**PLANNING APPROVAL &
SUBDIVISION STAFF REPORT****Date: December 5, 2013****NAME**

Knollwood Subdivision

Planning Approval to allow a 150' cell tower in a B-2, Neighborhood Business District, and Subdivision approval to create two legal lots of record from an existing lot of record.

DETAIL SITE PLAN

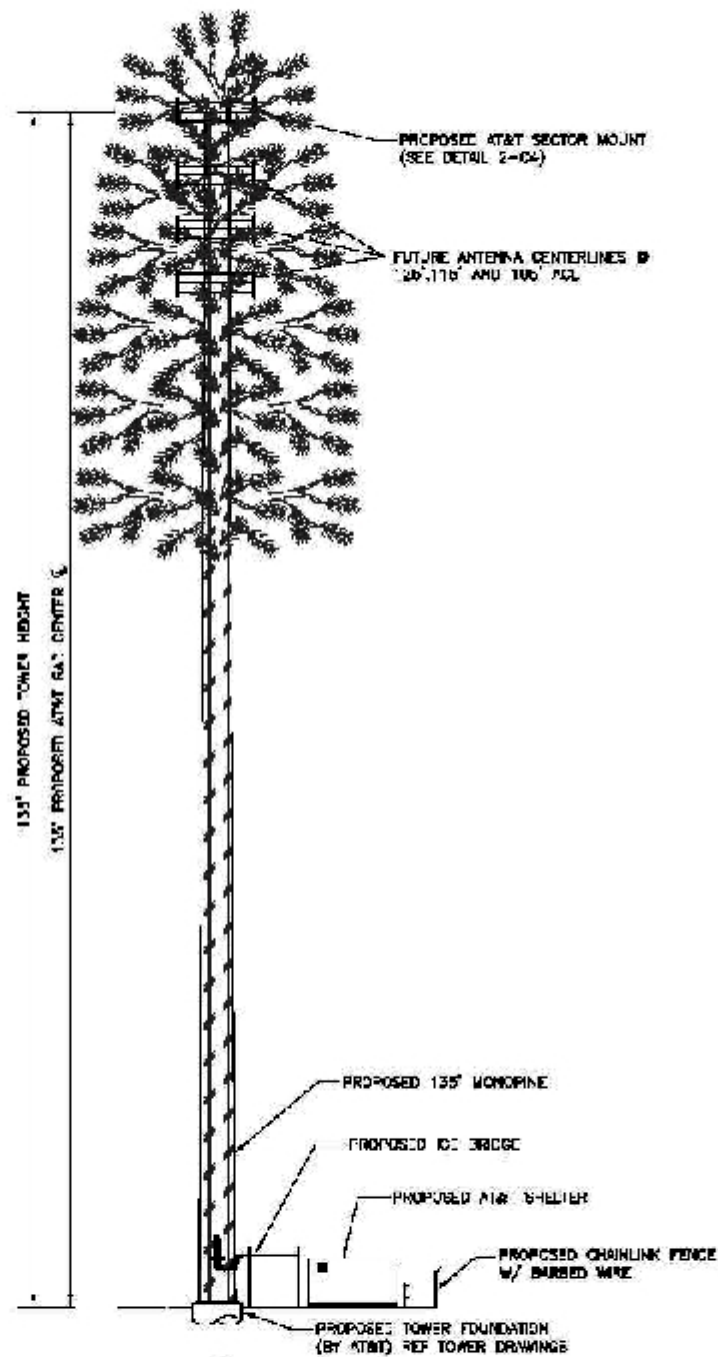
Concerning the Planning Approval application, the applicant has now reduced the tower height from 150' to 135' and proposes a tree-simulation camouflage design in keeping with Section 64-4.J.16. of the Zoning Ordinance. Although the height has been lowered, the top antenna array extends slightly above the 135' tower height. Therefore, that antenna array should be lowered

so that no portion exceeds the 135' tower height. Since the tower is now proposed to be of a camouflaged design, the top of the camouflage should not exceed 150' in height.

The lease area lot configuration has been revised to correspond with that of the Subdivision and the barbed wire atop the compound chain link fencing has been removed. The site plan has also been revised to provide a 6' high wooden privacy fence along the South side of the tower and equipment compound. However, since the lease area is actually the entire lot, the site plan should be revised to indicate this fence along the entire South side of the lease area lot.

One item not completely addressed is tree plantings. The site plan does not indicate a sufficient number of tree plantings and some tree plantings are indicated on the lease area lot and some are indicated off that lot on the adjacent new lot to the South. All required tree plantings must be on the lease area lot, and Urban Forestry has determined that sufficient area exists on that lot to provide compliant tree plantings. Therefore, the site plan should be revised to provide compliant tree plantings, all on the lease area lot, to be coordinated with Urban Forestry. Any required tree removal permits should also be obtained from Urban Forestry prior to any land disturbance activities.

- 1) revision of the tower elevation drawing to indicate the maximum height of the tower/antennae to not exceed 135' over-all height, and the maximum height of the camouflage tree pattern not to exceed 150';*

- 2) revision of the site plan to indicate compliant tree plantings, all on the lease area lot, to be coordinated with Urban Forestry;*
- 3) revision of the site plan to provide a 6' high wooden privacy fence along the entire South line of the lease area lot;*
